**Summary:** The Tentative Decision was distributed for public review between August 27, 2021 and September 10, 2021. The City received comment letters from the City Engineer and Albany Fire.

**Proposal:** The applicant is requesting approval to partition a 0.63-acre parcel into two parcels of approximately 10,802 square feet and 16,605 square feet with access from a private easement along Old Salem Road.

- A. Applicant: Sona Athwal  
6732 Seven Mile Lane SE  
Albany, OR 97321
- B. Project Location: 4962 NE Old Salem Road  
10S 3W 21D Tax Lot 0200
- C. Review Type: Table 5.01.030 of the Millersburg Development Code explains that a partition requires a Type II review, which is a staff level review with a 14 day notice provided to the neighbors.
- D. Public Notice: Notice has been provided pursuant to Chapter 5.07 and 5.18 of the Millersburg Development Code. Notice was provided to all neighbors within 100 feet and all responsible agencies on August 27, 2021. The notice provided 14 days to respond.
- E. Review Criteria: Chapter 5.07.060 Partitions
- F. Current Zoning: Residential Low (RL)

**TENTATIVE PARTITION PLAT**  
**SONA ATHWAL**  
**4962 NE OLD SALEM RD.**  
**ALBANY, OREGON

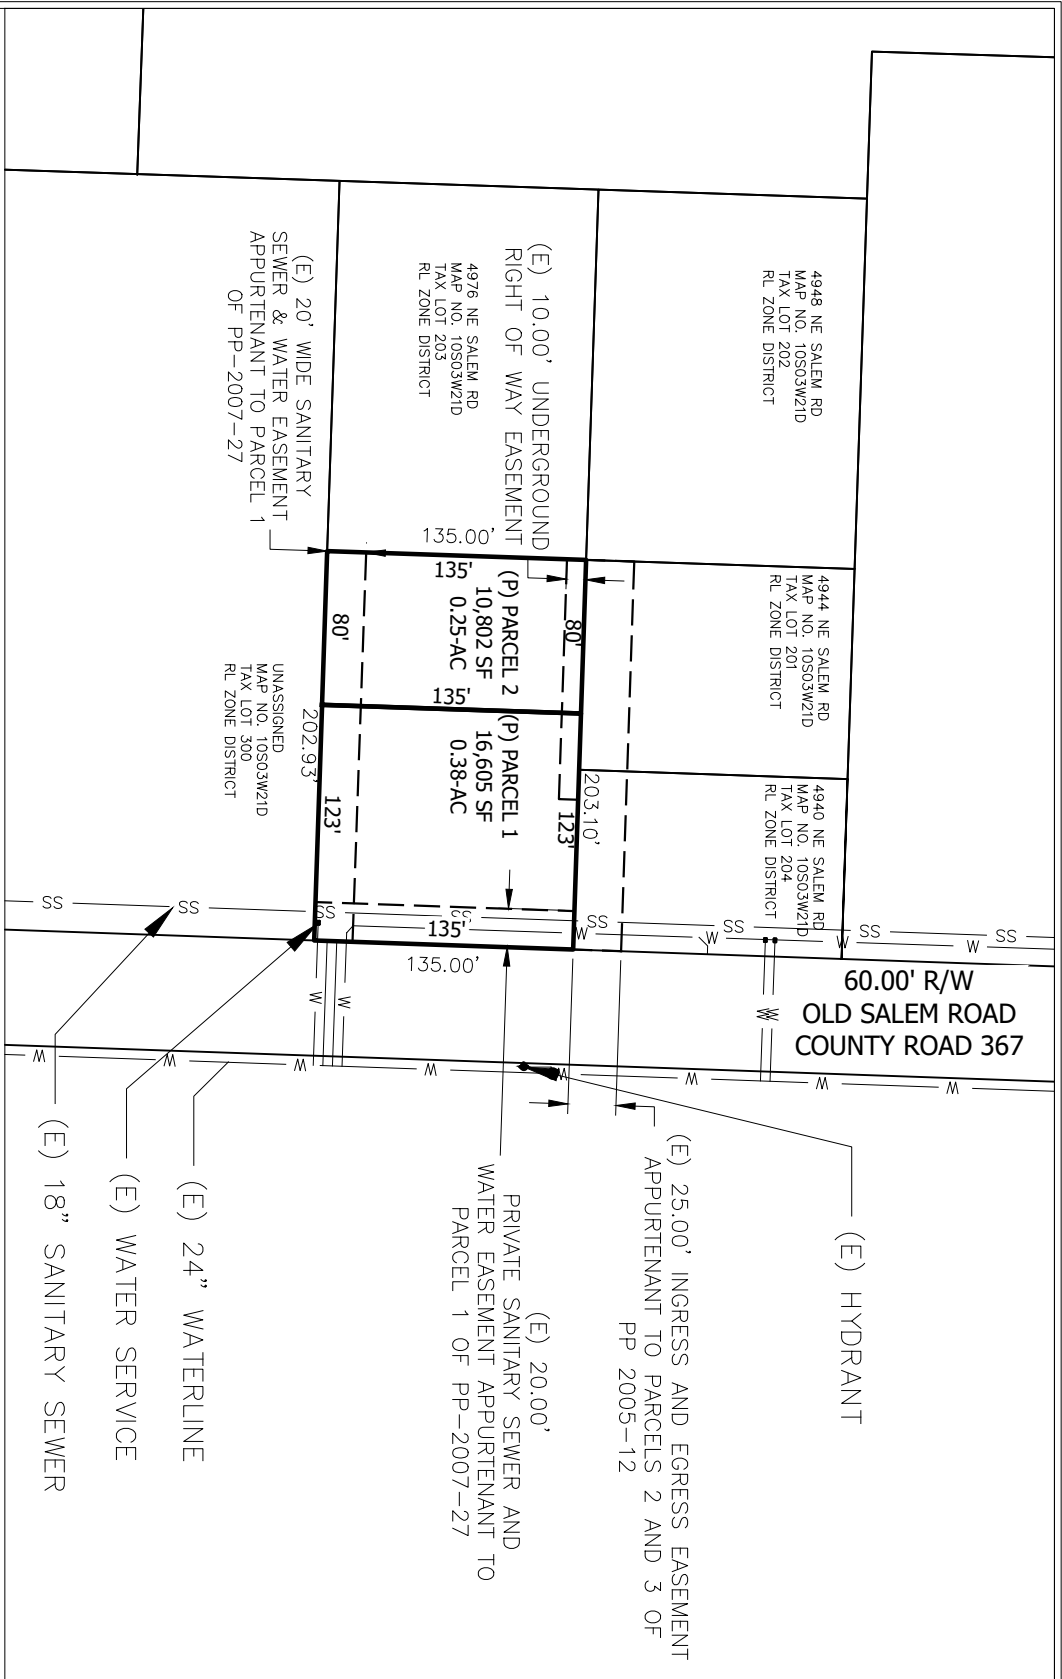
The following comments are provided based on the review of the vicinity map, tentative partition plat, and tentative decision for the above referenced Partition Application PA21-05.

The application indicates that there is an existing gravel drive that presently provides access to four residences and one vacant lot. The gravel drive connects to Old Salem Road that is within Linn County Right of Way and under the jurisdiction of the Linn County Road Department. The vacant lot is proposed to be divided into two lots. This will bring the total number of lots and future residences to six (6).

The gravel road is only 10 feet wide and is within a 25 foot easement that is 203 feet long. The gravel road provides access to Old Salem Road as it crosses a concrete sidewalk.

Adding additional development on this gravel road will require the following improvements to meet Linn County Code:

- Provide a paved 22 foot wide paved road surface with a minimum paved surface thickness of 4 inches placed in 2- 2 inch lifts. In any case, the minimum length of the paved surface should be 100 feet. The paved road surface will require an adequate road base with four foot wide gravel shoulders or a sidewalk concrete surface.

- Reconstruct the sidewalk crossing at the entrance from Old Salem Road so it provides a minimum entrance width of 22 feet. The reconstructed sidewalk access will be required to meet ODOT's current ADA requirements.

- Prior to the City approval of the final plat, the driveway shall be improved, to be at least 20 feet wide, and the access driveway for the section fronting the applicant's property shall feature paving at least 20 feet in width.

- Parcels shall take access through the existing shared driveway easement from Old Salem Road.
- The driveway from Old Salem Road shall be extended to feature a 22-foot wide paved approach and sidewalk reconstruction to meet ADA. Outside of the Linn County right-of-way the driveway must meet fire code and City of Millersburg requirements, including a 20 ft wide paved surface (asphalt or concrete) in accordance with Section 3.03.081 of the Millersburg Development Code. Due to existing conditions within the easement to the north, the proposed 10 ft underground easement along the north side of the property shall be extended to Old Salem Road and modified to include access to accommodate the full 20 ft pavement width. The driveway shall be paved for the entire length that is required for access to the two new homes that will be built on the proposed partition property (for both the shared driveway and the driveway in front of the garage doors).
